**Commonwealth Edison**

October 3, 1984

SUBJECT: Byron Generating Station Units 1 and 2, Technical  
Specifications, NRC Docket Nos. ~~50~~-454 and 50-455

The continuing review of the Byron Station Technical Specifications has identified additional changes as noted on the enclosed attachments. It is requested that these changes be incorporated into the final draft of the Technical Specifications dated August 27, 1984, from B.J. Youngblood to D. Farrer.

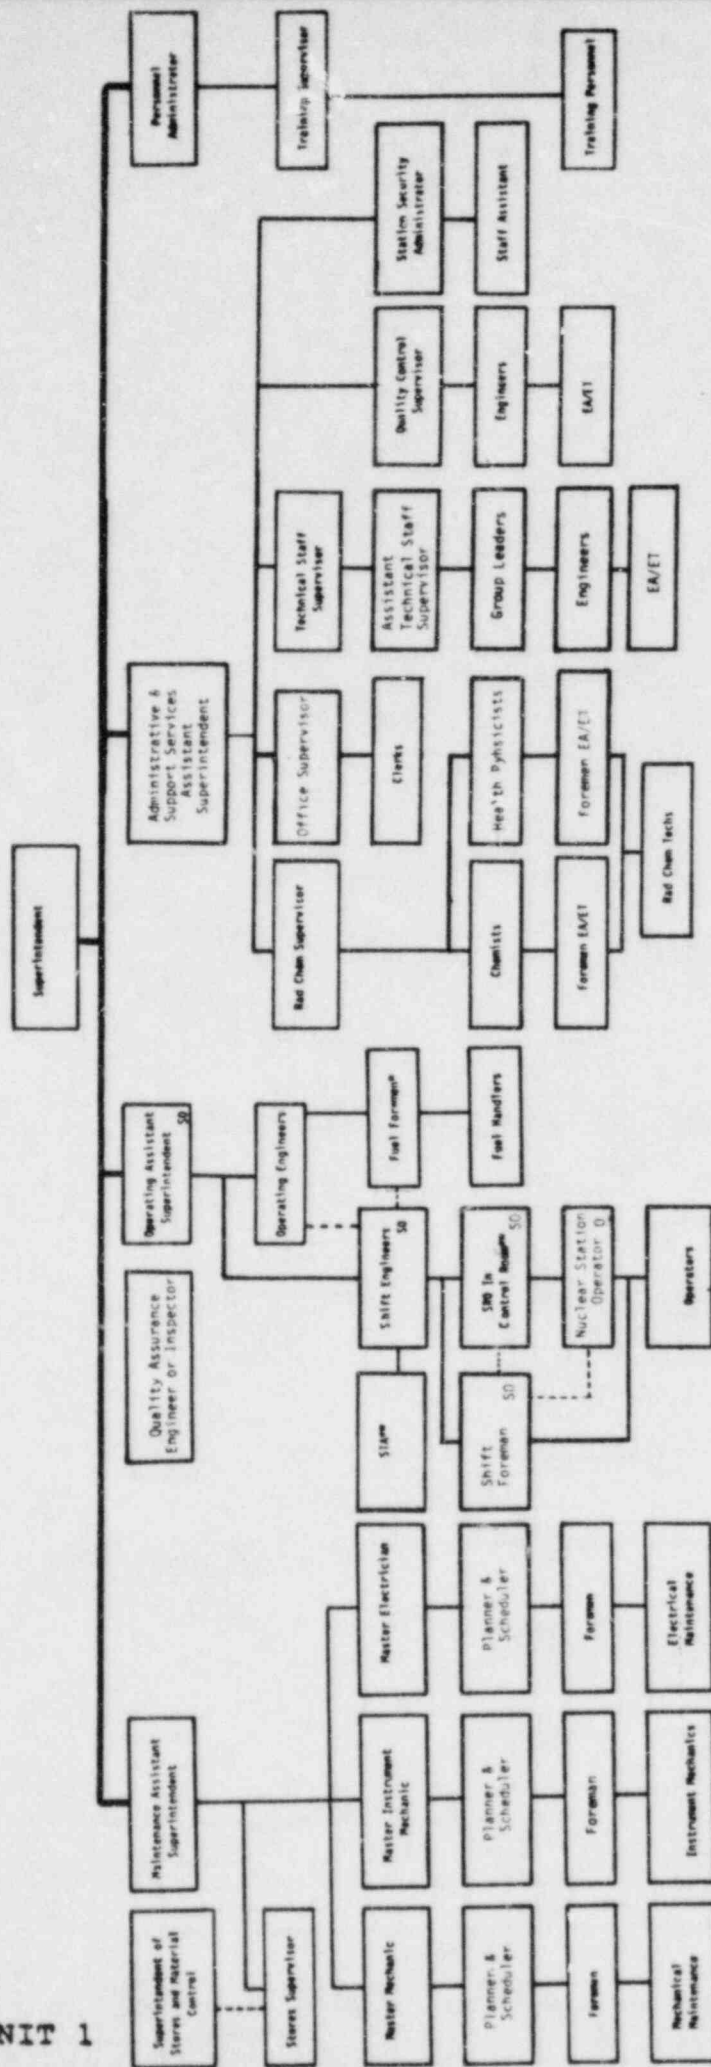
Byron Station proposes to change Surveillance Requirement 4.8.1.1.2.f 7) (page 3/4 8-5) as indicated on the attached copy.

- 7) Verifying the diesel generator operates for at least 24 hours. During the first 2 hours of this test, the diesel generator shall be loaded to ~~greater than or equal to 6050 kW~~ <sup>(+0, -150kW)</sup> and during the remaining 22 hours of this test, the diesel generator shall be loaded to greater than or equal to 5500 kW. The generator voltage and frequency shall be  $4160 \pm 420$  volts and  $60 \pm 1.2$  Hz within 10 seconds after the start signal; the steady-state generator voltage and frequency shall be maintained within these limits during this test. Within 5 minutes after completing this 24-hour test, perform Specification 4.8.1.1.2f.6b);\*
